Re: Final Remediation Plan  
Bell Gas #1186 (TR's Market), 101 Sun Valley Road, Alto, New Mexico  
Facility #912, Release ID #4547, WPID #18033

## Responses to Petroleum Storage Tank Bureau Comments Received January 15, 2021, Regarding Bell Gas #1186 (TR's Market) Final Remediation Plan

SHEET 5 OF 11  
 DWG NO. C-2  
 JOB NO.  
 ES14.0220

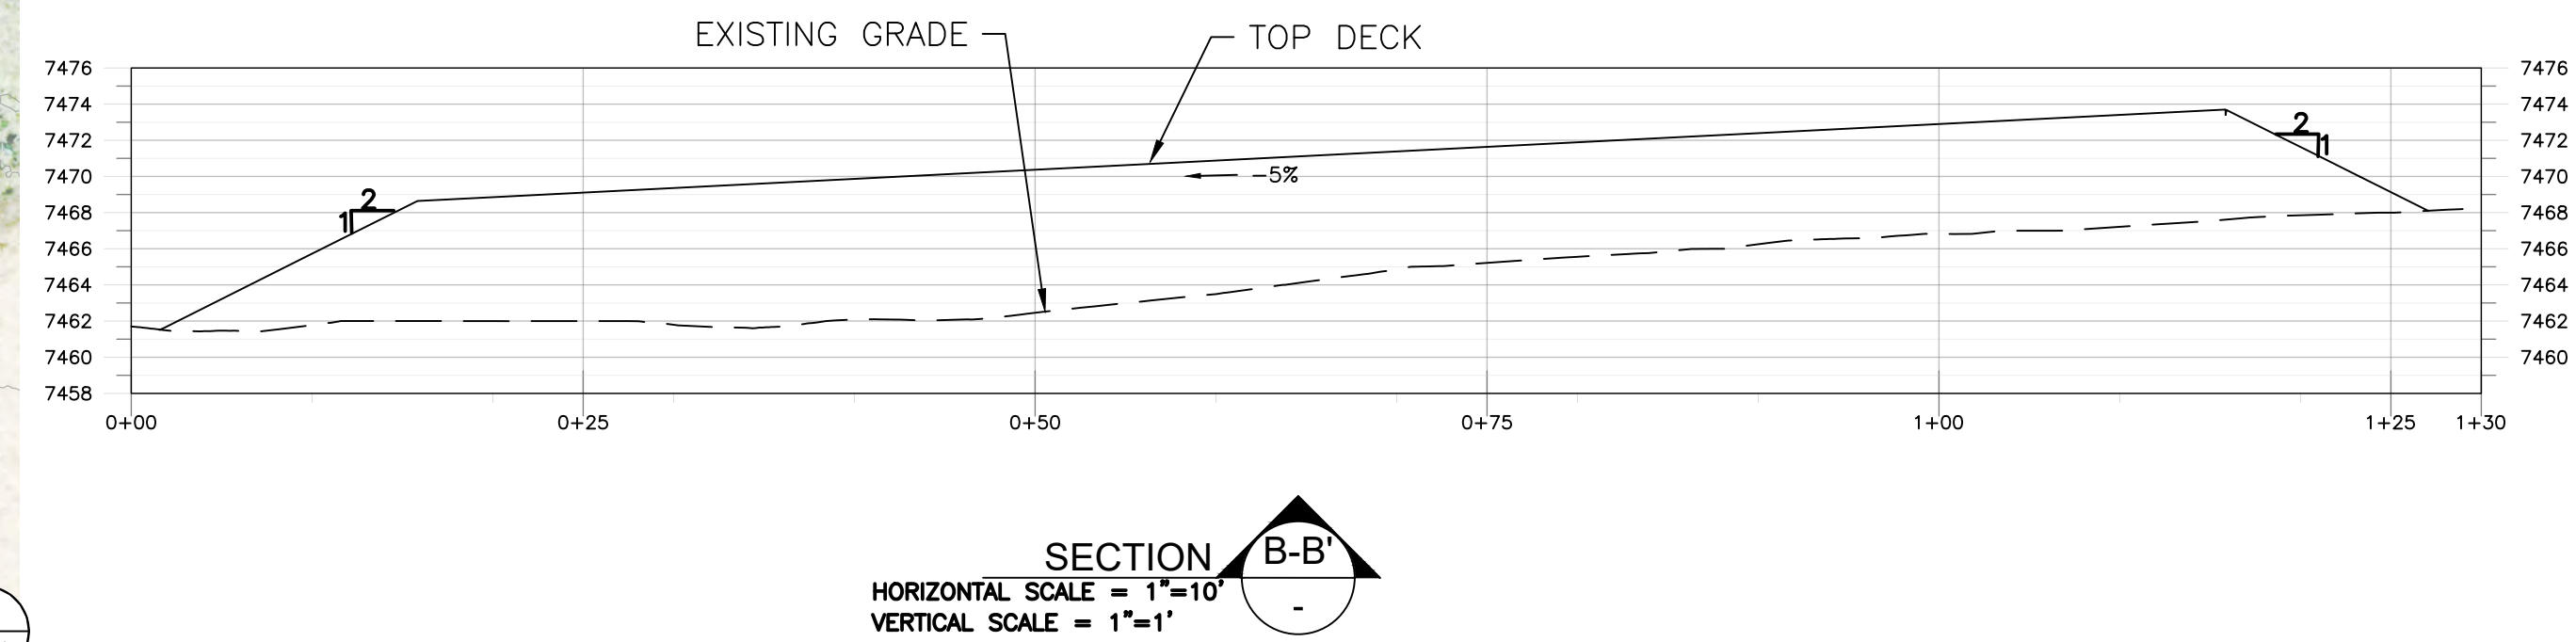
7. *Sheet 5 of 11: A -5% slope is depicted, yet Calculation ES14 0220-004 uses -10%. This will alter the Mound Fill Depth and subsequent calculations that use this in dimensioning the mound infiltration gallery. Please clarify and revise calculation as/if appropriate.*

The 5 percent slope depicted on the infiltration gallery plan is the surface slope along the length of the mound (top deck). The 10 percent slope used in the calculation approximates the existing ground surface slope on which the mound will be built, which is across the width of the mound (these two slopes are at right angles).

SHEET 8 OF 11  
DWG NO. M-1  
JOB NO.  
ES14.0220

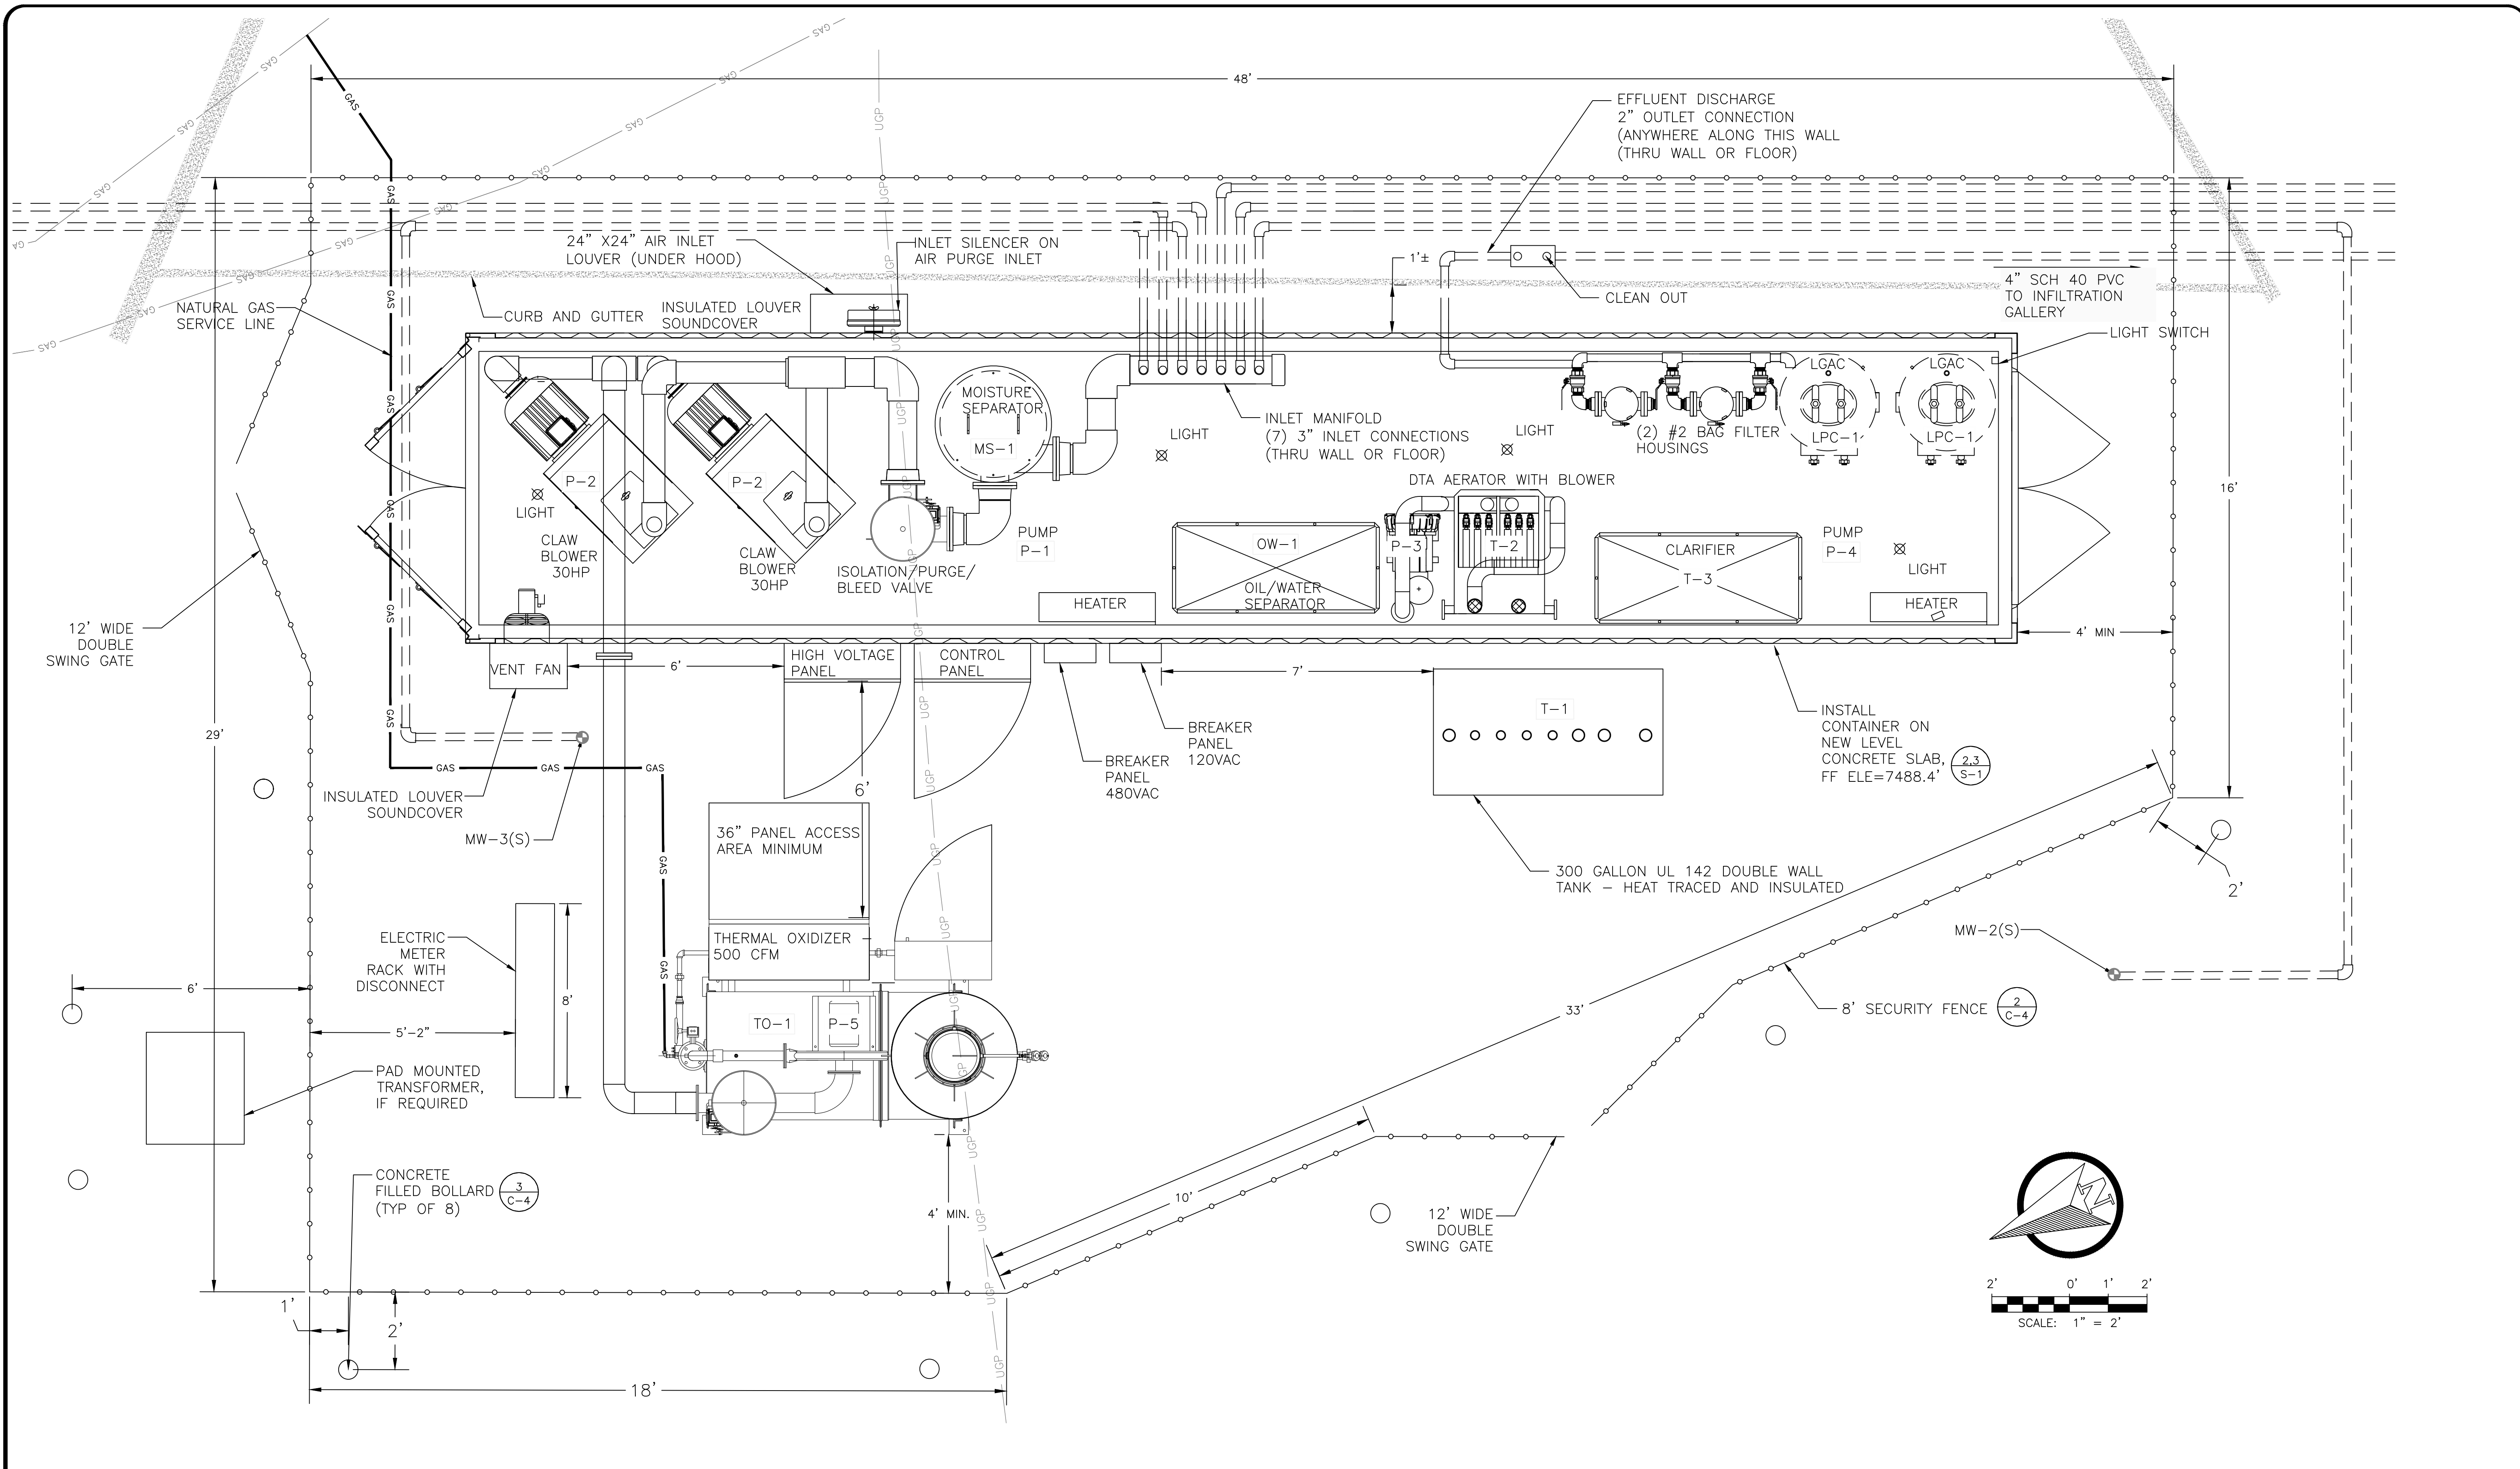
8. **Sheet 8 of 11:** *Please provide an additional legend on separate sheet for smaller elements on P&ID diagram that are not denoted.*

The piping and instrumentation diagram (P&ID) provided in the FRP was modified from the manufacturer P&ID, so DBS&A has limited ability to explain every symbol that was used on the original drawing. We included explanations (call outs) for the major components, so the treatment process can be clearly followed. DBS&A will attempt to acquire a legend from the manufacturer during implementation of the FRP. Alternatively, DBS&A would be happy to schedule a Teams call to review the P&ID in detail and address any other questions PSTB may have on the proposed design.
